BURLINGTON DEVELOPMENT REVIEW BOARD Tuesday October 4, 2016 PUBLIC HEARING NOTICE

BURLINGTON DEVELOPMENT REVIEW BOARD Tuesday October 4, 2016, 5:00 PM Contois Auditorium, City Hall, 149 Church Street, Burlington, VT AGENDA

To: Development Review Board
From: Mary O'Neil, AICP, Principal Planner *mwneil*
Date: October 4, 2016
RE: ZP17-0214CA

To: Development Review Board
From: Mary O'Neil, AICP, Principal Planner *MO*
Date: October 4, 2016
RE: ZP17-0250CA; 42 Alexis Drive

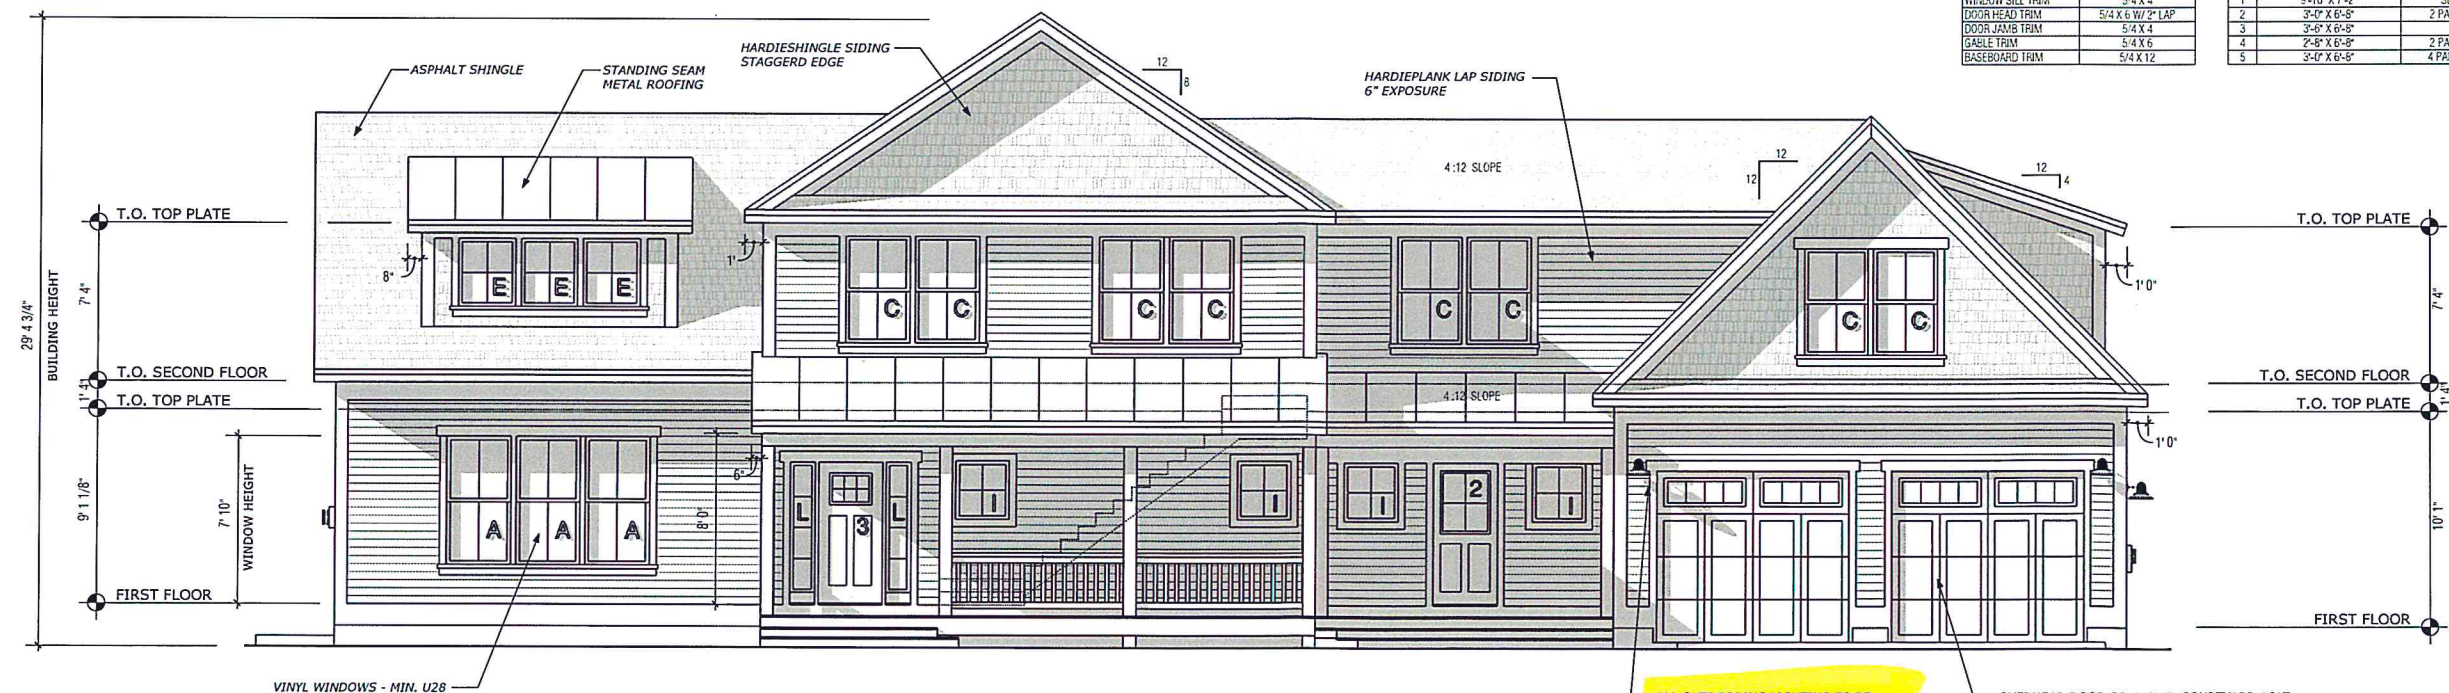
Plan A.06 includes a notation that *All outdoor lighting to be down lit, white light with max output of 1200 lumens*. As presented, it meets these standards. **Affirmative finding.**

RIGHT SIDE ELEVATION

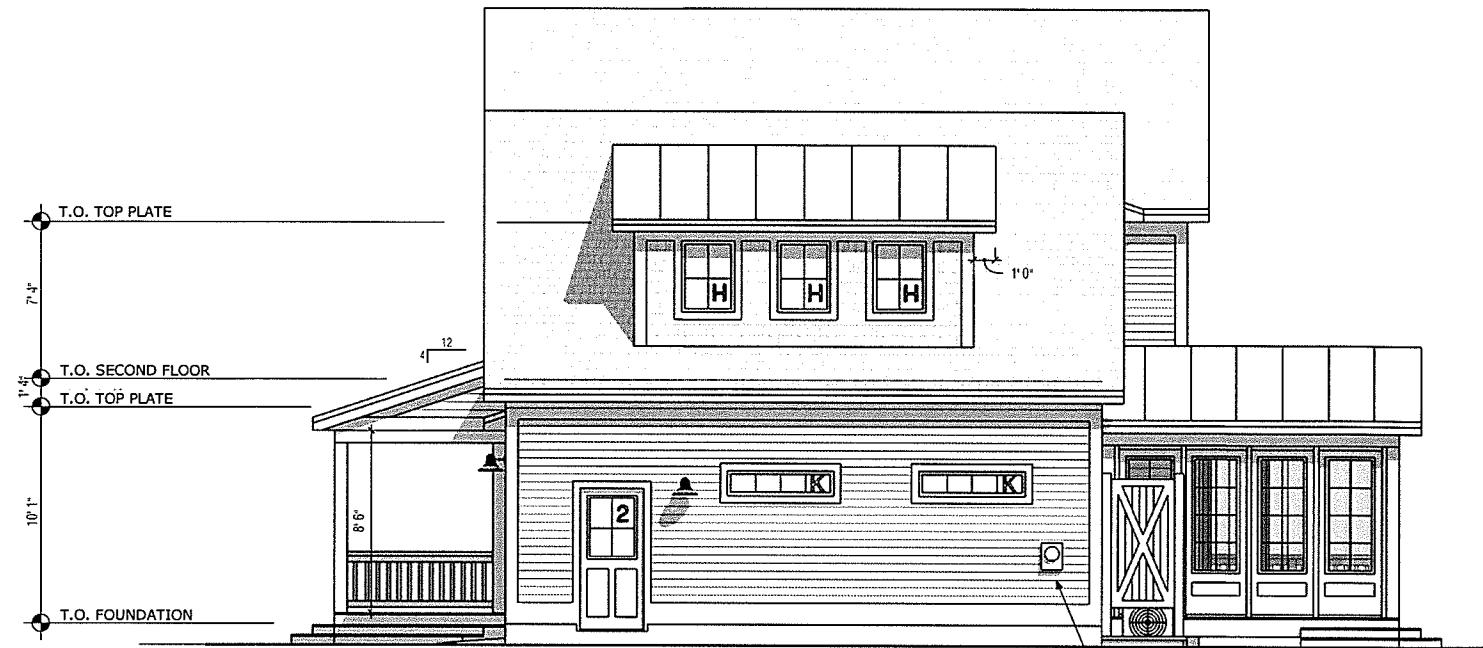
New utility lines must be buried. A ground mounted condenser is illustrated on plan A.07; this appears to be less than 16 sf and would therefore meet the exterior HVAC exemption under ZAI 11-01. As it is located on the rear of the structure, no screening is required. A utility meter is illustrated on the north (side) elevation; a fireplace vent on the south. There is no gas connection illustrated (if applicable.) Screening may be required for meters, utility connections and HVAC equipment. Mail is delivered to a central street cluster mailbox. Trash and recycling will be located within the garage. **Affirmative finding as conditioned.**

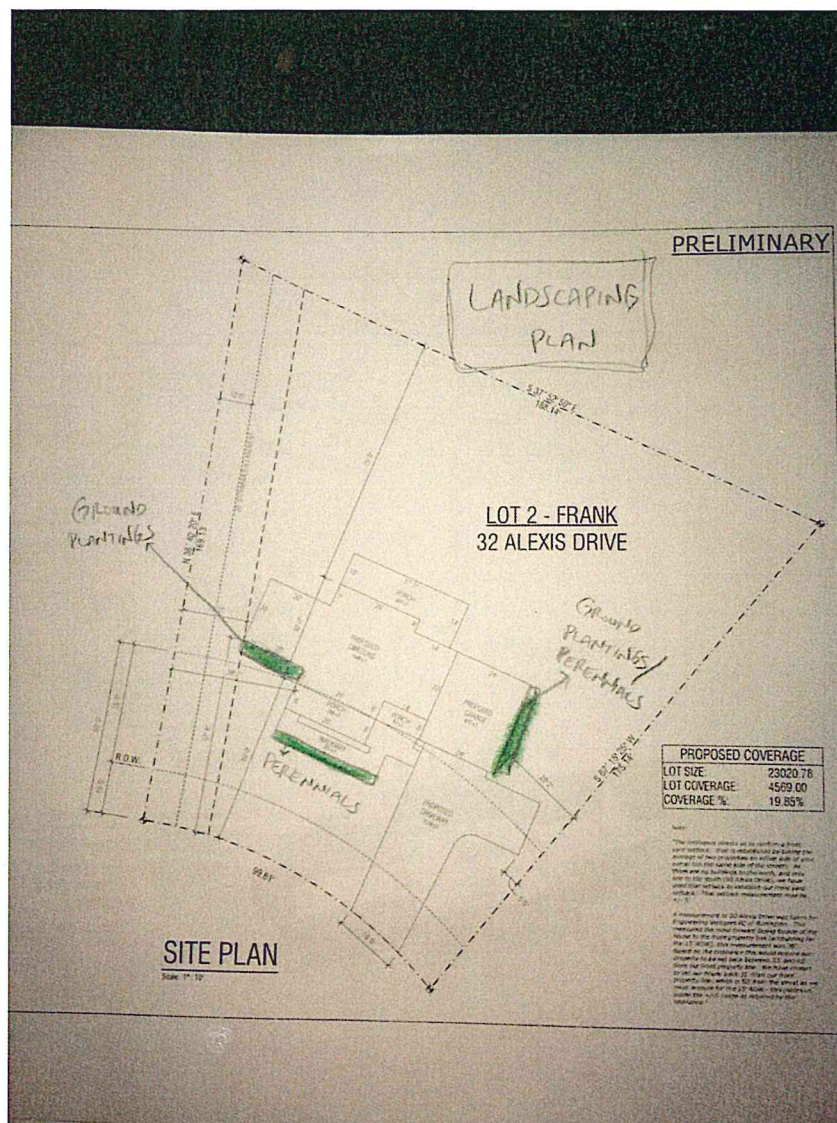
Your tree guy is going to have to give more information than he has provided. What are the existing conditions? What are the species/breakdown? What area needs thinning? Which trees are a threat? What do we need to remove as many trees as we propose? Do the existing trees provide a significant privacy or aesthetic buffer to another property? How will the site be treated after the tree clearing?

You need this information to provide the Development Review Board with enough evidence to approve your plan. Without it, you risk your project going forward, and open you up to appeal. You want to be able to answer their questions before they even ask.

The lot is .53 acres and it has never been trimmed, thinned, pruned or landscaped in any way. There are too many trees to inventory. There appears to be several tree species, many fallen trees, low lying brush, etc. Our plan is to clear an area large enough to accommodate for the proposed footprint of the new structure and remove any and all dead, diseased, rotted or infested trees (this is a large number of the trees on the lot). We will remove any additional trees that may pose danger to life or the future state of the property. We hope to save many of the trees as we can to provide a natural landscape. There are many large pines on the lot that are rotten and pose risk to the house and future inhabitants - this became further evident during a recent storm during the summer of 2016 as several large, rotted pines fell on the property (please see attached photo taken on 8/24/16). Had the structure been in the proposed location on the site plan it would have been significantly damaged. We have consulted with a professional tree removal company (DJ's Tree Service) who would be responsible for completing the work and they advised that very few of the trees on the lot are in healthy condition and they recommended clearing most, if not all of the lot to ensure that our new structure is not damaged and that we remain safe. We even had them explore the possibility of us using some of the lumber from trees that would be removed for our project and they informed us that this would not be possible given the condition of the trees. For the trees that do require removal DJ's will leave roughly 1-2 feet of stump (to be removed later by the excavator). Any trees and/or brush that is removed will be hauled away and not disposed of on the site. The excavator will remove and dispose of all stumps (disposal will not be on the subject property). Following the completion of the project we will plant grass in the front and rear of the home to match the existing landscaping theme present in the rest of the development.
